ADDENDUM | No. 1

PROJECT	MCWC 2021 Improvements – 250,000 Gallon Water Tower No. 6A
BID DATE	1:30 PM Thursday, January 20, 2022
BID LOCATION	Minnehaha Community Water Corporation Office 47381 248 th St. Dell Rapids, SD 57022
ISSUE DATE	Monday, January 10, 2022
NOTICE	Failure to acknowledge all addenda in the BID may cause rejection of the BID. See Instructions to Bidders.

Date: 1/11/2022**Project:** MCWC Water Tower 6A**To:** All Bidders**Project #:** BS21006**From:** Connor Swiontek PE**Project Location:** Humboldt, SD**Addendum Number:** 1

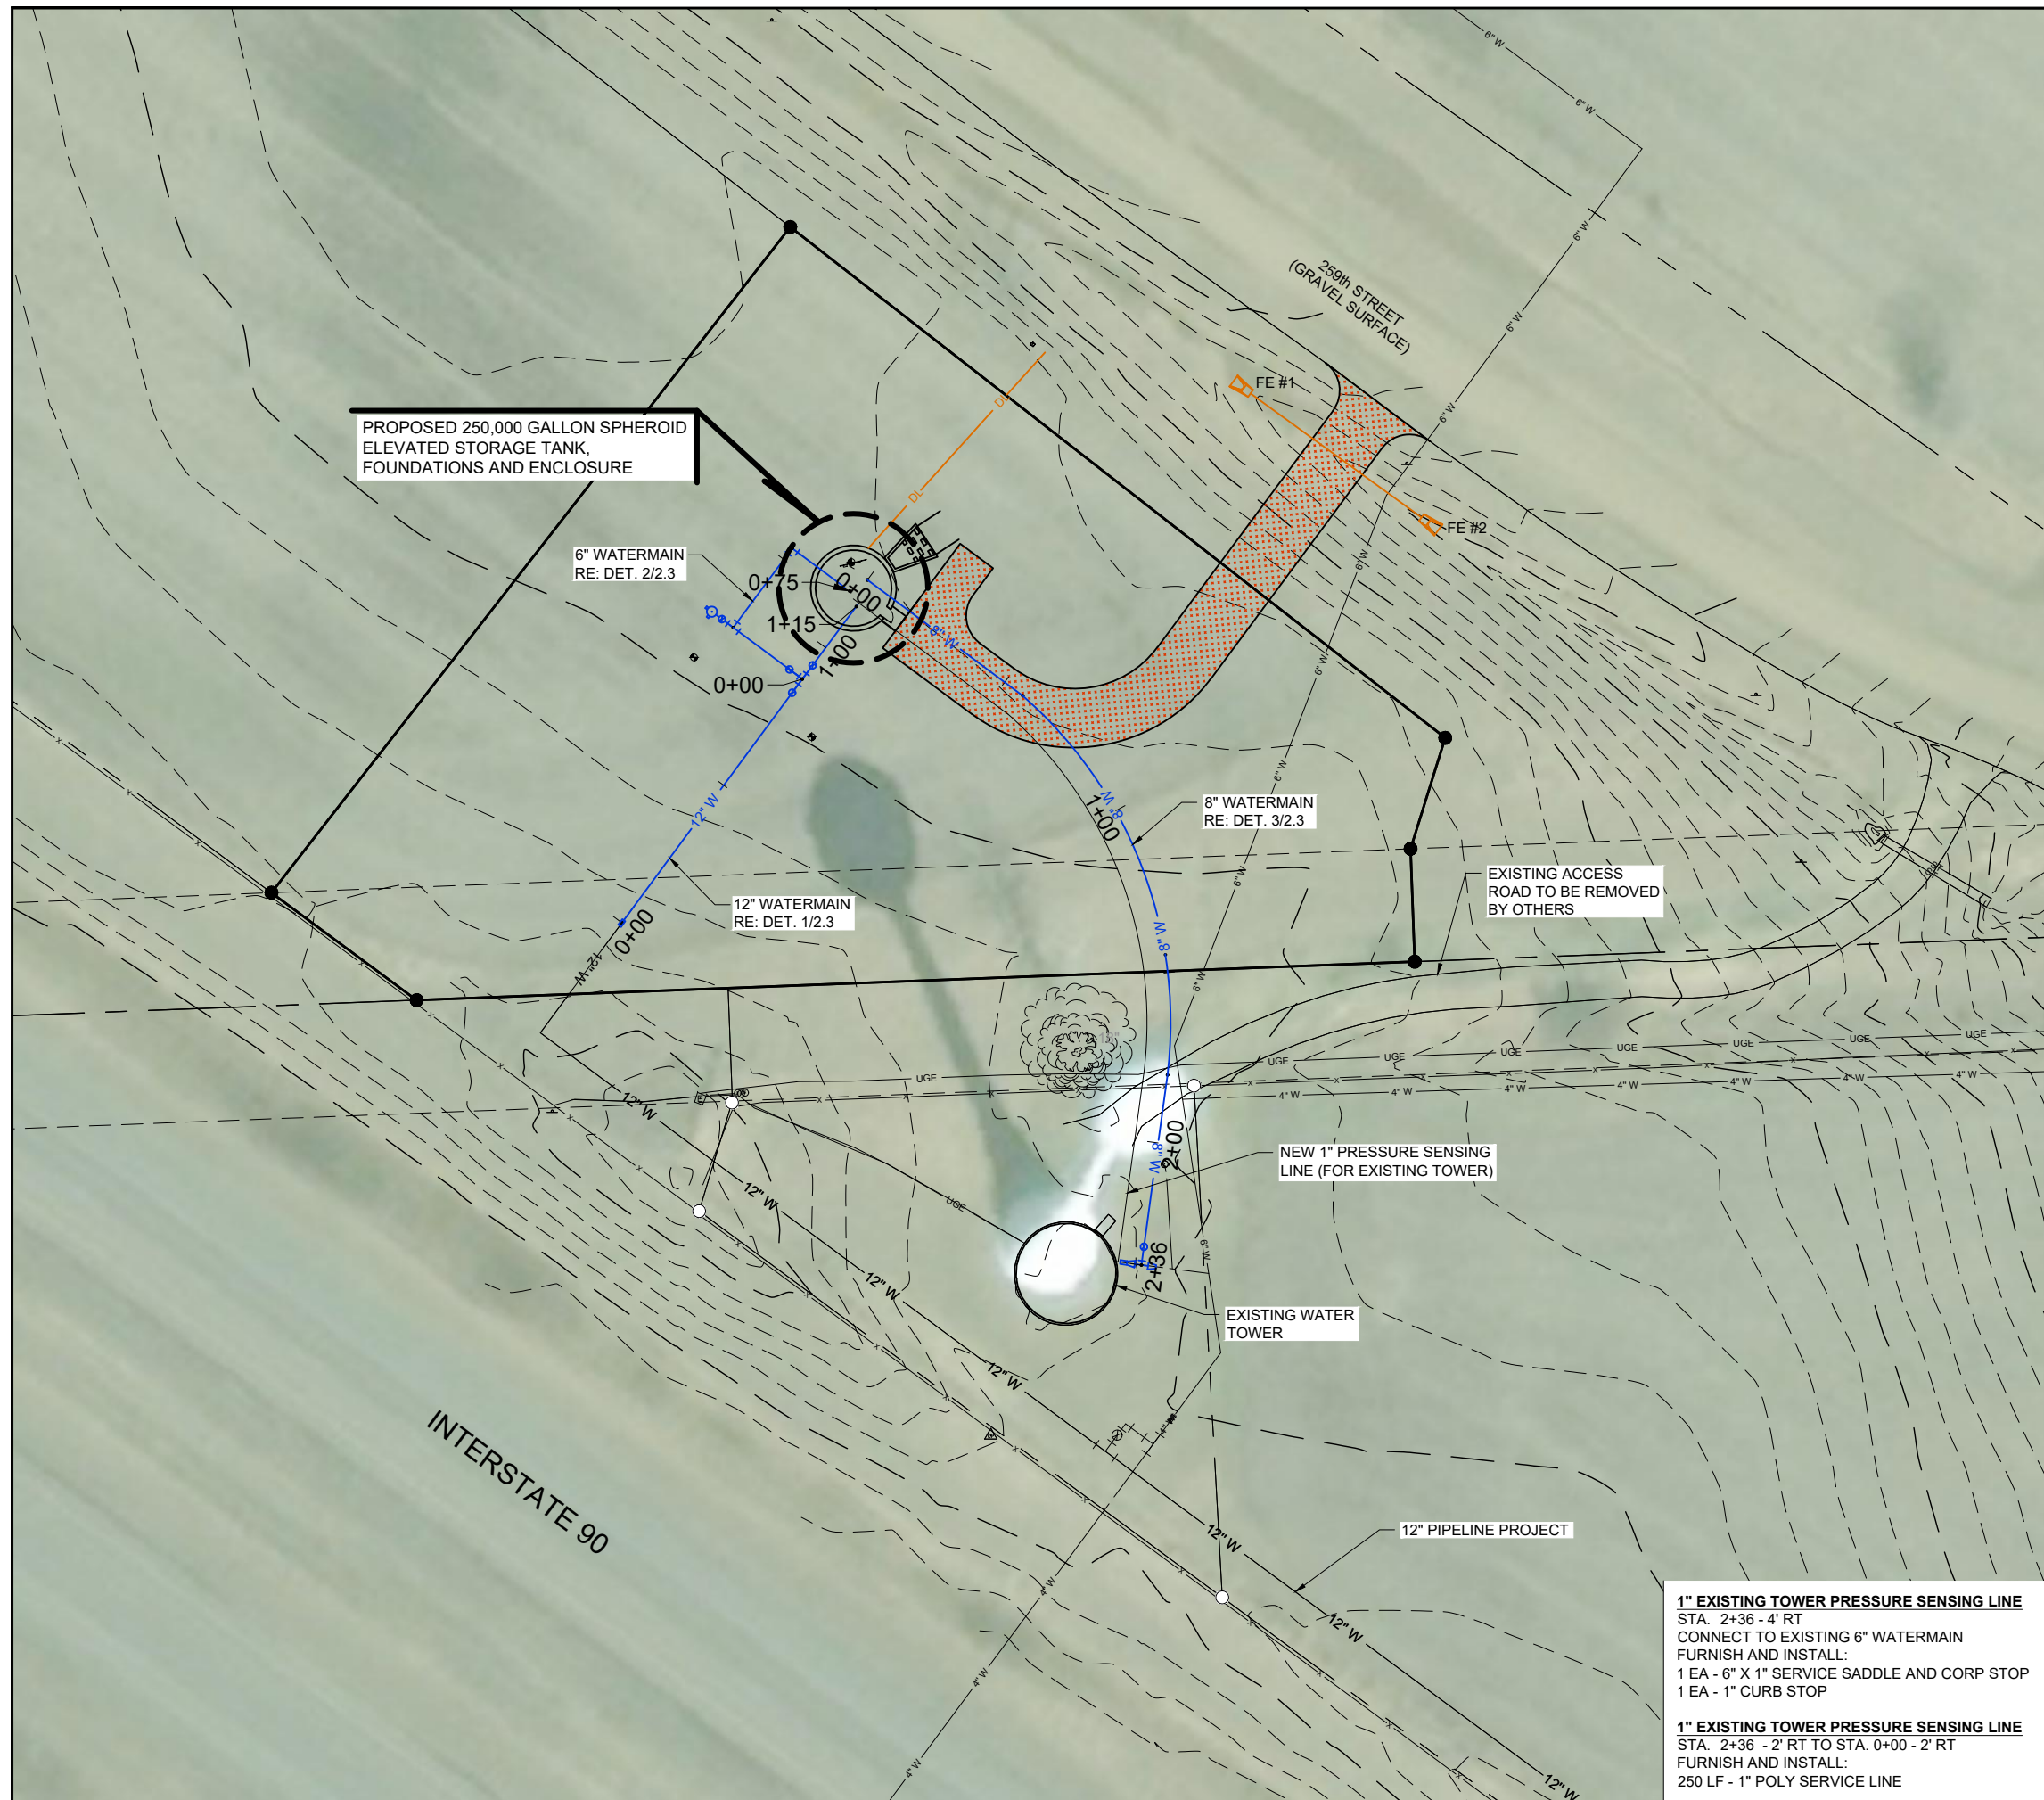
Product Approvals
